Staff Summary Report

SUBJECT: Hold a public meeting for a Development Plan Review for THE DISTRICT GARAGE located at 929 East Apache Boulevard.

DOCUMENT NAME: DRCr_TheDistrictGarageElev_062612 PLANNED DEVELOPMENT (0406)

DPR12088 – Development Plan Review including a building elevation modification to the parking garage.

1 WEST ELEVATION - PARKING GARAGE
SCALE: 1/32" = 1'-0"

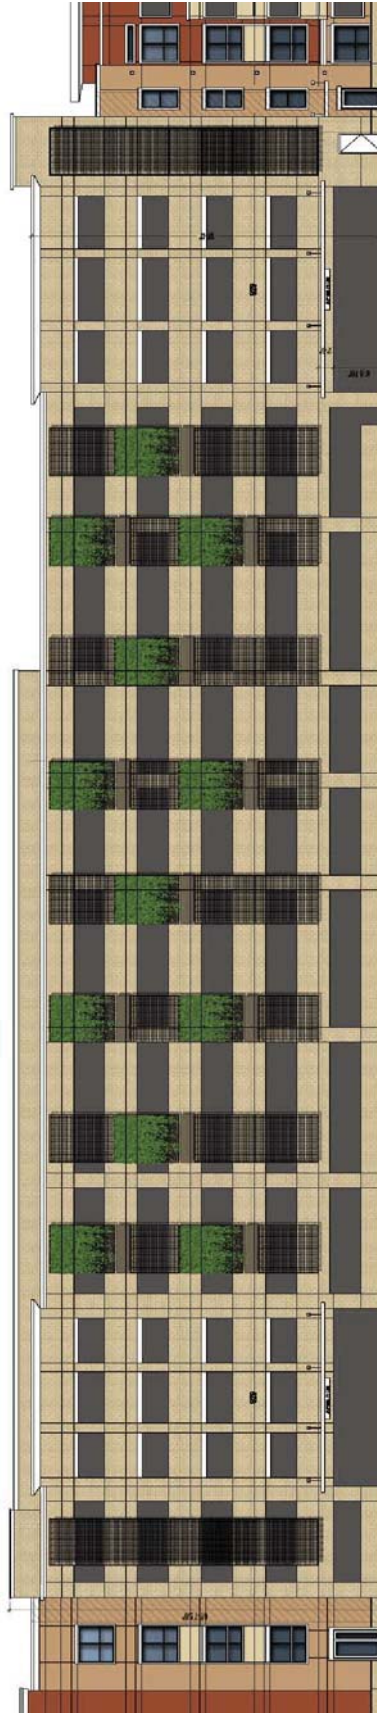
The proposed modification will reduce the amount of metal screen with foliage on the west elevation of the garage and allow this elevation to contribute to the natural venting requirement of the garage. The architect and landscape architect have substituted a composition that makes use of a layered concrete and metal screen design. The painted concrete structure with horizontal openings is superimposed with vertical metal screen elements of uniform width spaced in a somewhat irregular row along the length of the elevation. Each screen extends from the second level to the top of the structure. Each of the screen elements contains a portion which contains a horizontal planter box and vine. The screen elements with vines are equally sized in width and height. The planters are at the bottom of each element and (by condition of approval) a growth break is added at the top to prevent vine creep onto areas that are required for ventilation. The screen elements with vines are not placed at a uniform height but are staggered to add interest to the elevation.

6. Indicate material and finish of metal screen and detail installation of screen to garage structure. Design the screen so it is not accessible and climbable by persons from the ground or from any intermediate or top level of the garage.
7. Design the metal screen with a growth break between the portion of screen on which vines may climb and the portion which is restricted from vines due to garage ventilation requirement. Design screen with segregated vine portions to satisfaction of building safety plan check so ventilation requirement for garage is fulfilled.

-  GREEN SCREEN: CALCULATED AT 0% OPEN
-  OPEN MESH: CALCULATED AT 85% OPEN
-  GARAGE OPENING: CALCULATED AT 100% OPEN

1 SITE PLAN
SCALE: N.T.S.

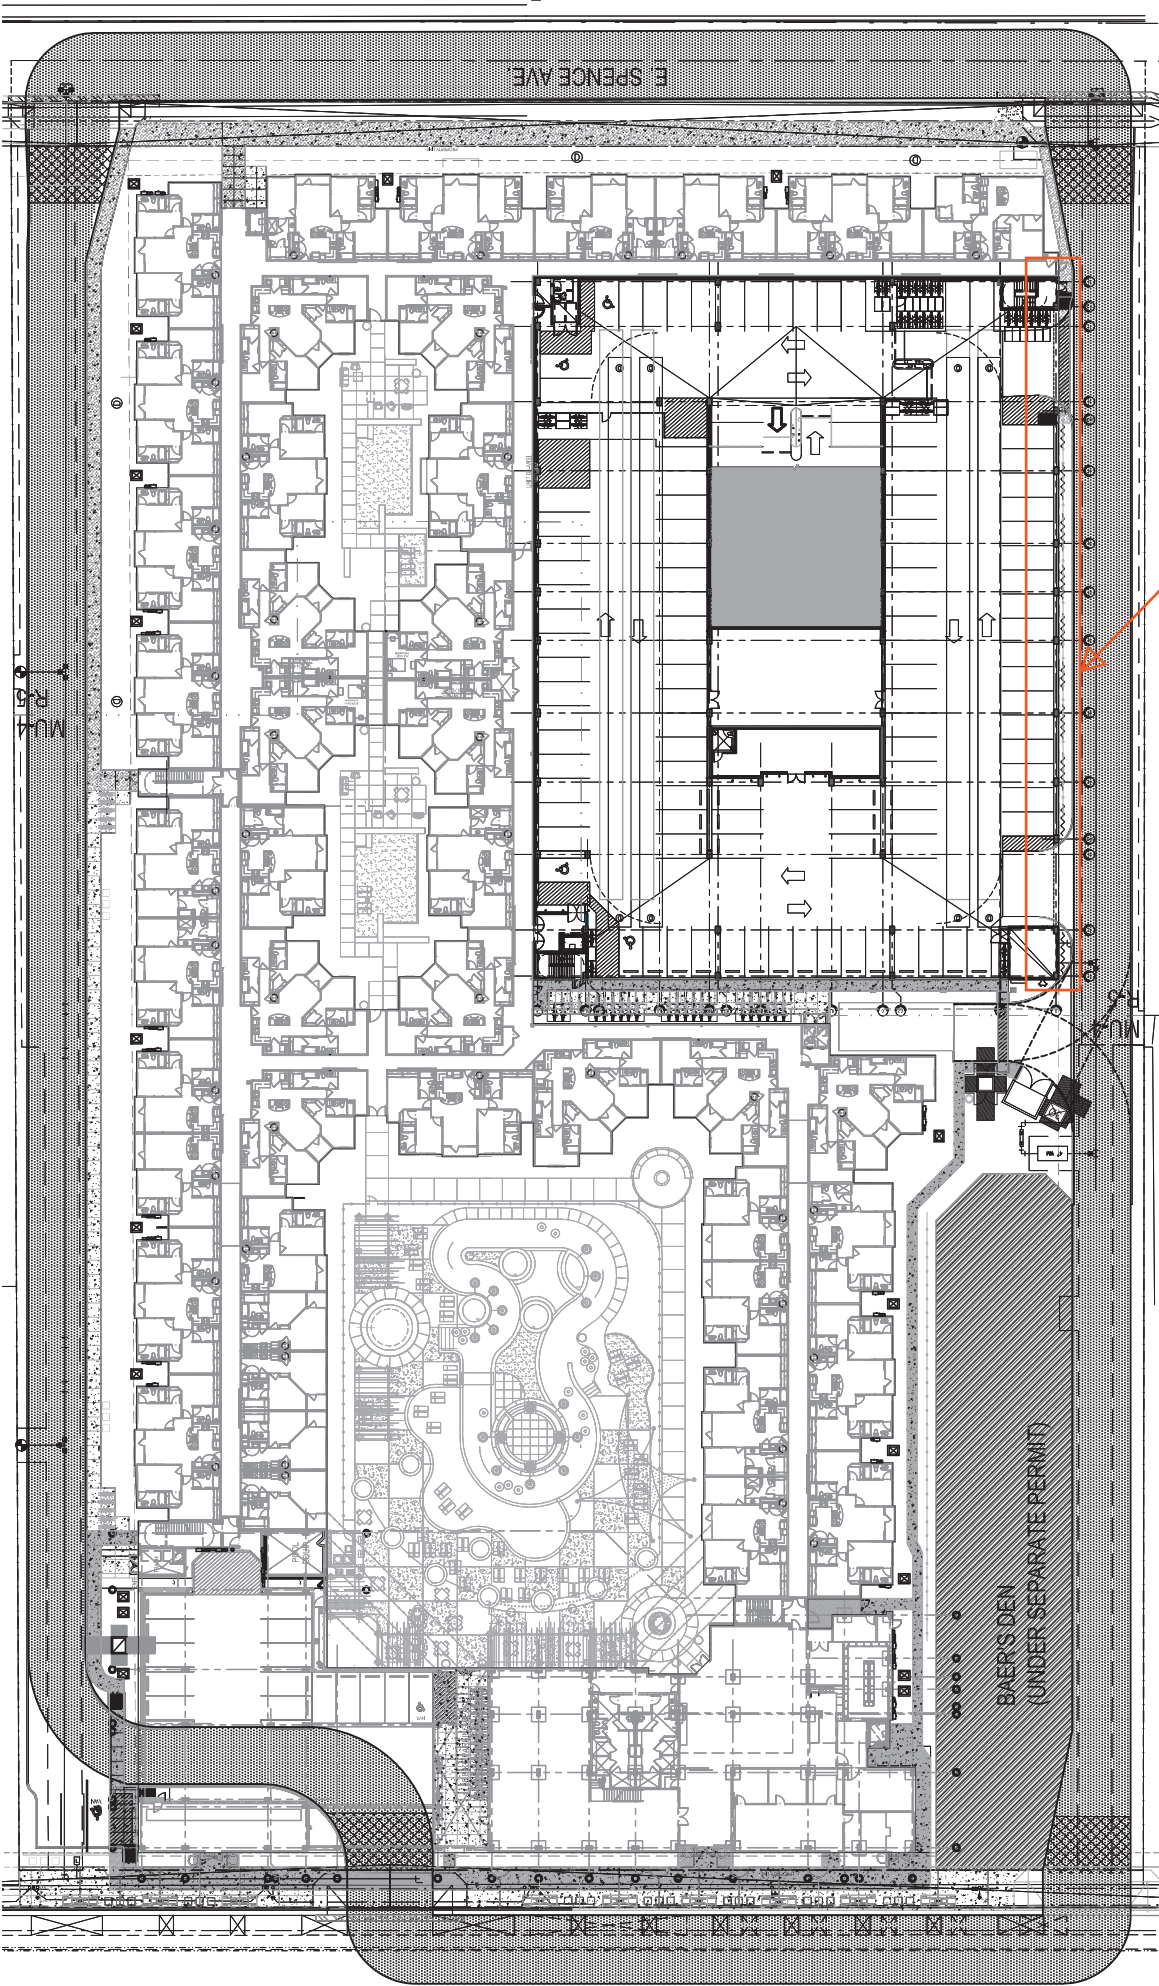
3. Install west landscape (tree) buffer adjacent to the hotel property. Do not wait for installation of rest of landscape for the District but install this buffer to allow an extra growth season for trees ahead of construction of the building and garage. Remove compaction and construction debris from planting soil, install concrete curb, 36" box Live Oak (*Quercus virginiana*) trees, supporting irrigation system and steel vertical picket fence along the entire west perimeter of the District in accordance with condition 17 of DPR11120 (as modified by the Development Review Commission on August 23, 2011) and in accordance with the approved landscape plan for the District (BP111764). Complete installation within sixty (60) days of issuance of deferred submittal permit for the District garage. Ensure minimum 4'-0" clear width of the curbed buffer planting area, which may include the steel vertical picket fence and the trees but may not include the width of the concrete curbs. After installation, take care to protect the soil and trees of the buffer from construction dumping or other damage during the remainder of construction. Installation of root guard under pavement as well as purple trailing lantana and desert carpet plant groundcovers and decomposed granite rock groundcover within the curbed area may at contractor's option be deferred until the regular landscape installation at the conclusion of the construction sequence.

4. Provide 6'-0" high steel vertical picket access control fence along west property line in accordance with condition 6 of DPR11164 and in accordance with the approved landscape plan for the District (BP111764). Install fence as part of the west landscape buffer in accordance with detail 5/L-10 of the approved landscape plan. Complete installation of this access control fence within sixty (60) days of issuance of deferred submittal permit for the garage.
